To: Kathryn Espinoza, McKim & Creed
From: Brian Chambers, Senior Planner; 910.342.2782
CC: File;
Date: 11/2/2022
Re: Riverlights SF 7 & 8 TRC Rev 2

Project Name: Riverlights Conventional Phases 7 & 8
Formal TRC Date: 10/24/2022
Reviewer: Eric Seidel, PE
Department: Engineering – Plan Review Section

RIVERLIGHTS CONVENTIONAL PHASE 7 & 8
 MASONBORO TOWNSHIP, WILMINGTON, NEW HANOVER COUNTY, NORTH CAROLINA

OVERALL SITE PLAN

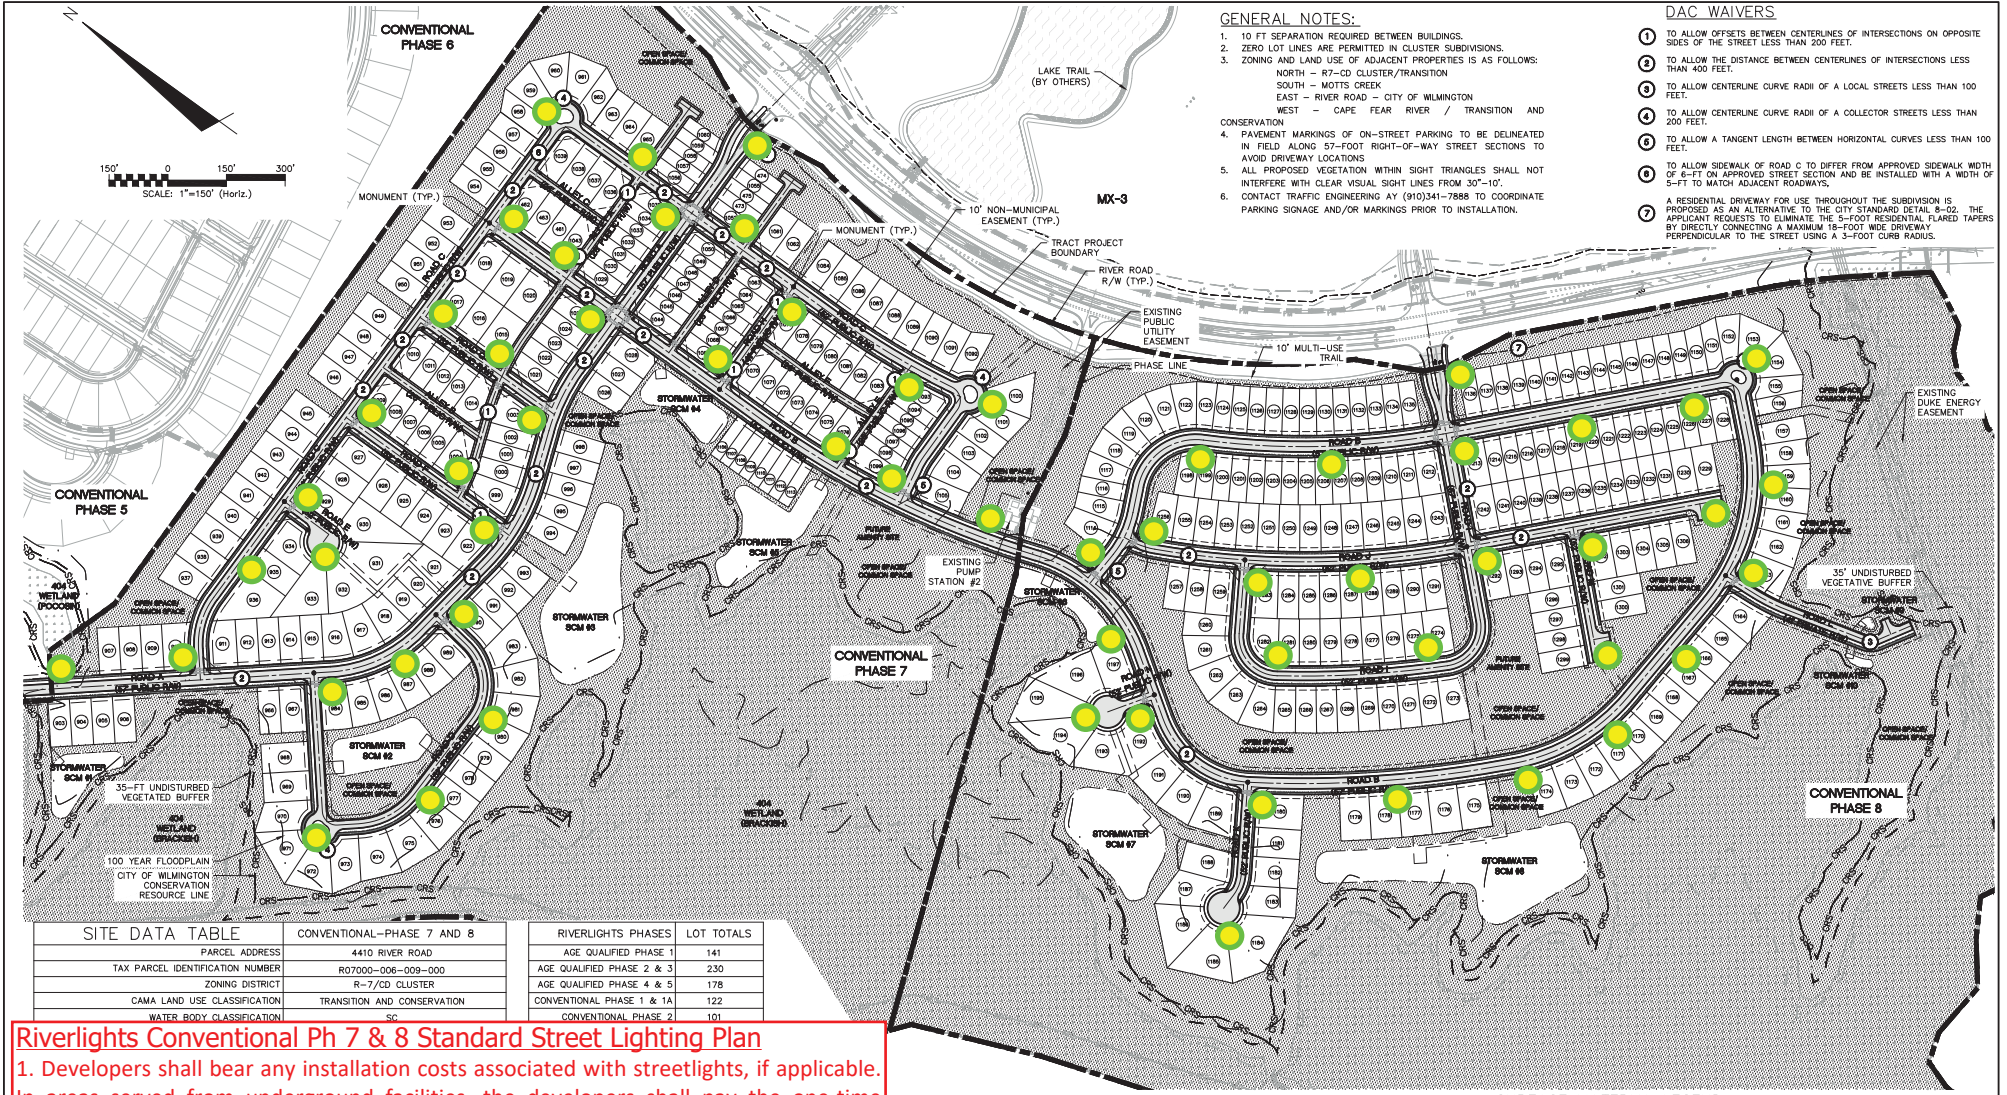
1. Callout official proposed street names on plans.
2. Cul-de-sac on Road D in front of Lot 972, Road C in front of Lot 960, and Road B in front of Lot 1153 will be acceptable without central island. Please revise to remove the central island.

3. Bulb on Road C in front of Lot 1100 should be considered for revision to make a traditional road curve. This would allow continuous sidewalk on both sides of street. It may potentially increase few of the lots size. No central island or ramps are required.
Note: The above comments 1 & 2 are from pre-TRC review & As per the email communication on 01/25/2022. The requirements are not satisfied. Sidewalks are shown continuous as requested but central islands are not removed. Please revise accordingly.

4. If central islands are preferred, please provide all possible turning movements of vehicles maneuvering around and backing out from the driveway of those lots into cul-de-sacs lanes. This is to justify that the lane width proposed are sufficient for the traffic maneuvering.

5. Provide the turning movements of the largest vehicle maneuvering at all the cul-de-sac/bulbs.
6. Dimension the median width for Road A and Road I, connecting River Rd.

- Provide line type details for lanes and tapers provided at the median of River Rd connections of Road A and Road I.
- Add 'Area wide' plaque with speed limit sign in accordance with City standards.
- 'No parking any time' signs proposed in the vicinity of all intersections are not required. If installed shall be in accordance with City LDC Sec 5-52.
- Street sign shall be in accordance with City standards and not as per MUTCD. Revise the details. <https://www.wilmingtonnc.gov/home/showpublisheddocument/12338/637781800549130000>
- Revise the locations of 'Keep Right' signs to show it as close as practical to approach ends of raised medians such that traffic will have to pass to the right-hand side of the sign [MUTCD].
- Crosswalk markings at all the internal non-signalized intersections are not required and shall not be installed.
